July 5, 2011

RE: CUYAHOGA COUNTY
CITY OF ROCKY RIVER
GRAND VIEW SUBDIVISION
NPDES PERMIT NO. OHC000003
OHIO EPA PERMIT NO. 3GC01961*AG
CONSTRUCTION STORM WATER

Figure 2. Geotextile fabric under the grate is not an acceptable inlet protection.

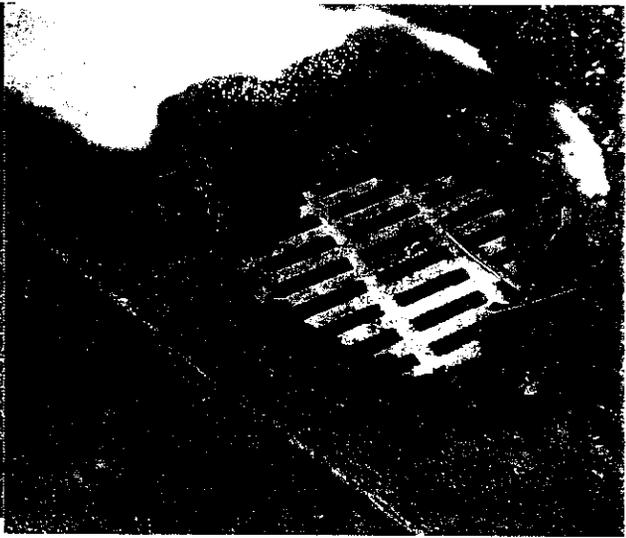
- There appears to be several catch basins that are not protected, or have inadequate protection on the driveway to the subdivision. Simply stretching geotextile fabric under the grate is not an acceptable form of inlet protection. Please carefully remove geotextile from under the grates to prevent sediment from falling into the basin, and refer to the ***Rainwater and Land Development Manual***, *Ohio's Standards for Storm Water Management, Land Development and Urban Stream Protection* (attached) for specifications on appropriate inlet protection practices (See Figures 2 & 3).
